**TELSTRA CORPORATION LIMITED**

**Response to the ACCC's draft pricing principles and indicative  
prices for LCS, WLR, PSTN OTA, ULLS, LSS**

9 October 2009

**Error 2: The Analysys Model does not take into account the fact that joints and pits/manholes are required to connect one gauge of cable to a different gauge of cable<sup>78</sup>**

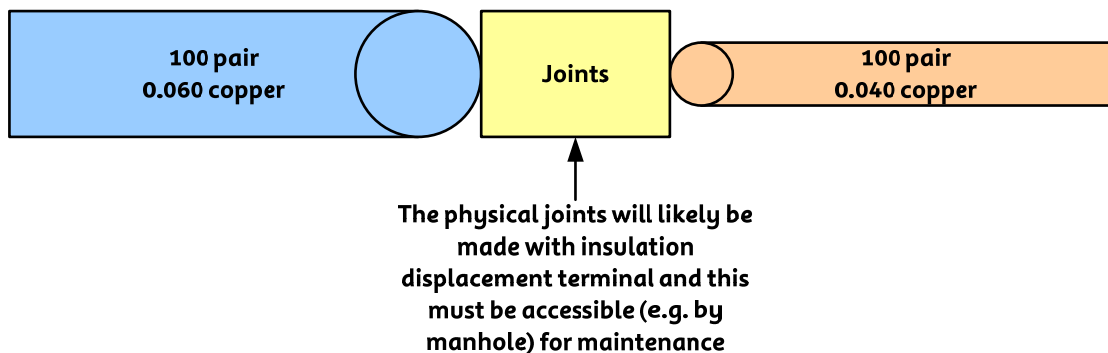
- 8 The Analysys Model acknowledges that different gauges (or thickness) of cable will need to be connected together. In order to connect cables of different gauges, a pit or manhole is required to access the cables which are to be connected and a joint is required to connect the cables. Below is a diagram illustrating the connection of two cables of two different gauges.<sup>79</sup>

- 9 The Analysys Model does not take account of the need for a joint and a manhole or pit to enable the two cables to be connected.

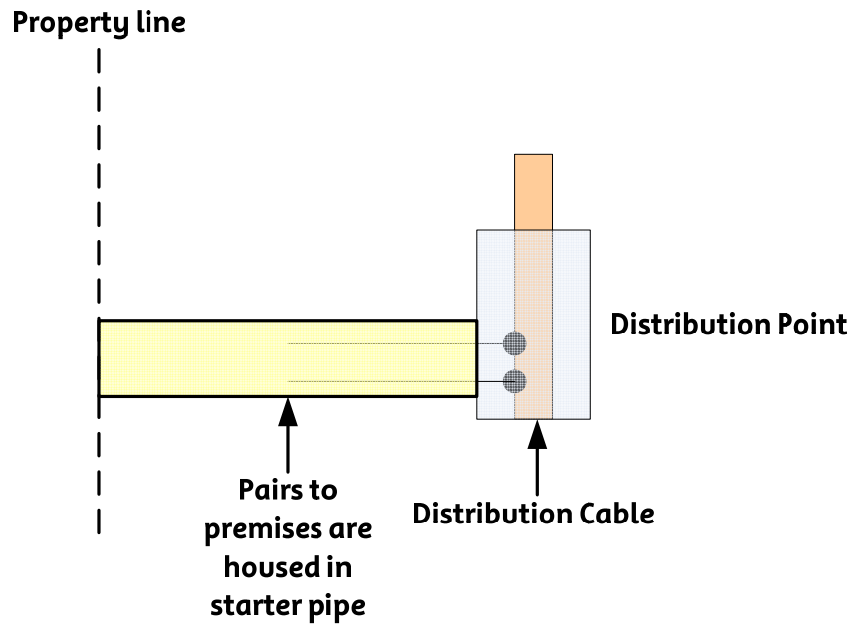
- 16 Below is a diagram of the connection from a distribution pit to a customer’s property boundary. The connection requires trenching, conduit and cable to run from the DP to the customer boundary.

- 17 While the customer is responsible for the trenching and other costs on his or her side of the property boundary, the trenching and conduit between the DP and the property boundary form part of the distribution network – they are dug at the same time as the distribution cable trenches and not on a customer by customer basis at the time of connection.

- 19 The error can be fixed by including the costs of the equipment (e.g., cable and conduit) required for the lead in up to the property boundary. We have corrected the Analysys Model by adding in these costs less the difference between the fee for new connection and the reconnection charge (see explanation in Attachment A).

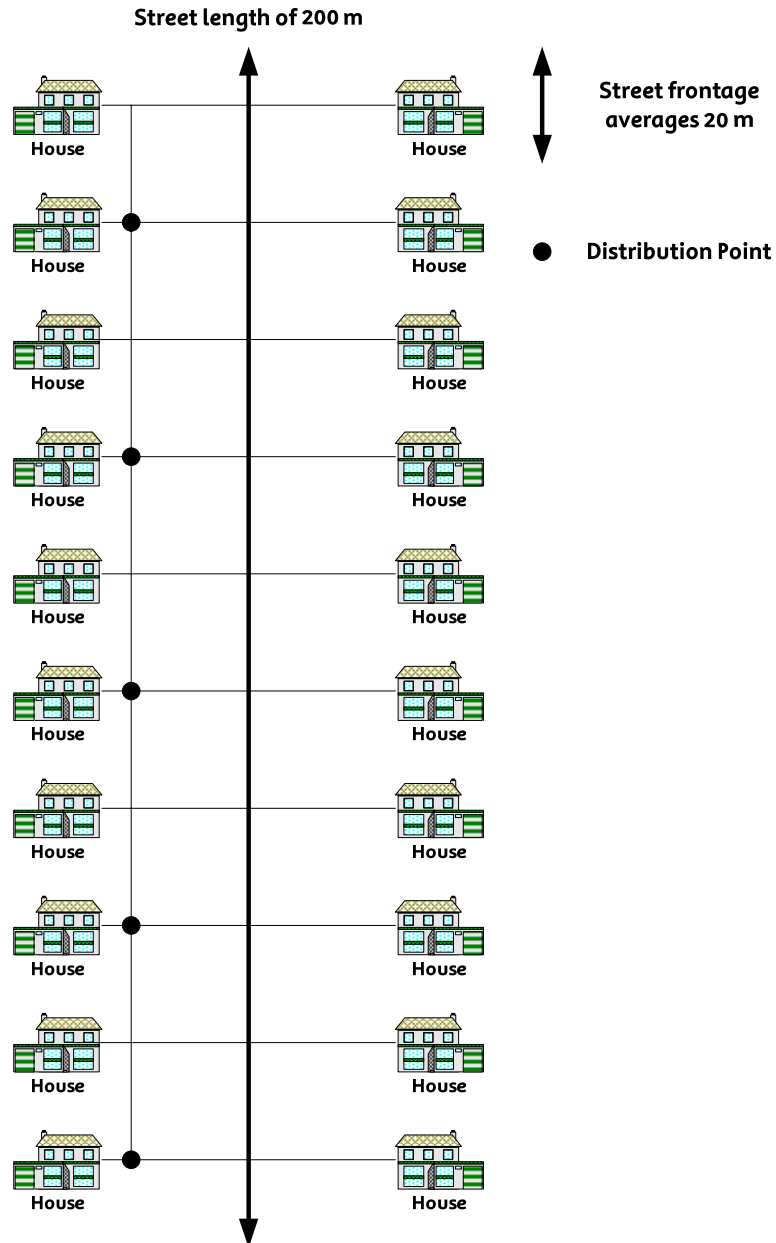
- 20 Below is a diagram of the distribution pit architecture used in the Analysys Model. The network is built on one side of the road with each distribution pit serving from one to four houses. The model provides for trenching and conduit for the cable from the distribution pit to the other side of the road but does not provision sufficient length of cable sheath to serve the homes on the opposite side.

Note: the comparison above is not from the Analysys Model but from a corrected baseline that includes the correct ducts/cables necessary for the correct serving pit architecture.

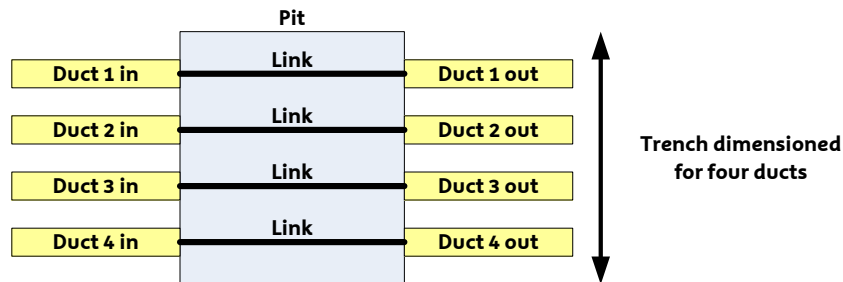
ACCC dimensions the pit for single duct in and out and dimensions the trench accordingly

Pit dimensioned for 4 ducts in and out and trench dimensioned accordingly

### **Error 10: The Analysys Model accepts that a particular pit size is required but then fails to use that size<sup>85</sup>**

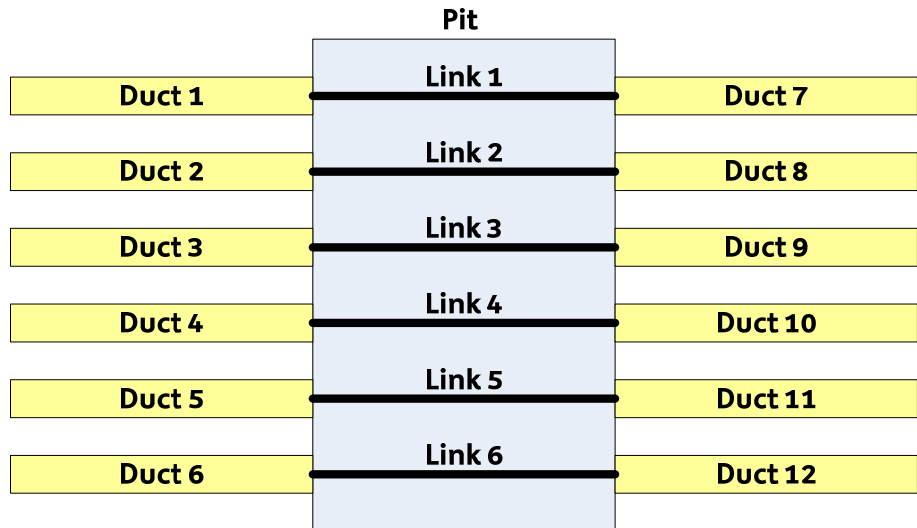
- 34 A pit is an underground piece of equipment used to access joints and cables. The size of a pit is determined by the number of ducts in the pit and the number of links coming into the pit. Each pit must be large enough to accommodate both the number of ducts and the number of links into the pit. If a pit has six ducts and two links, it will need to be big enough to accommodate six ducts.<sup>86</sup> Below is a diagram of a pit showing the number of ducts and links into the pit.

**Figure 5: Adjusting the tilt in the Analysys model**

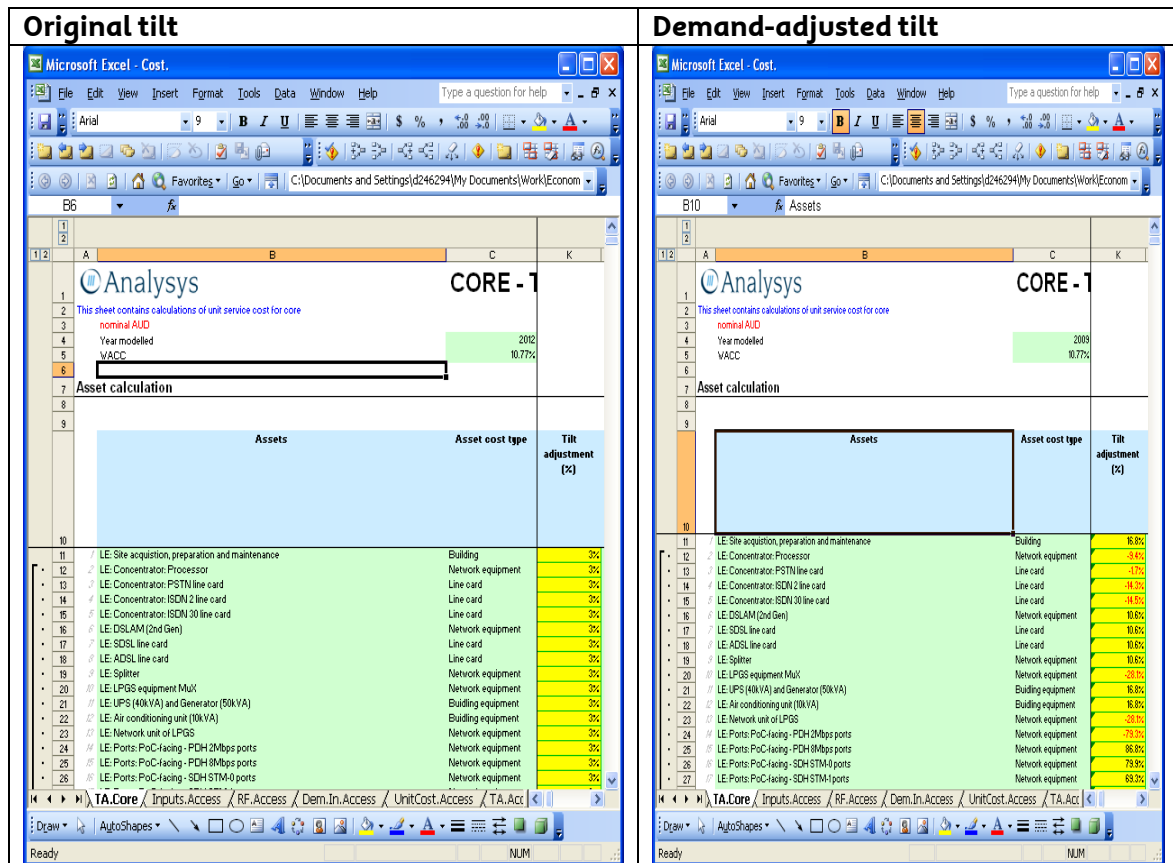
- 12 As an example, the adjustment in the core model (sheet TA.Core) is shown in Figure 5 below.

- 13 When the tilt is adjusted for trends in demand in this way the model results are again altered significantly. The output for ULLS in Zone A rises to \$30 and the output for WLR in Zone A rises above \$30 (Table 39).
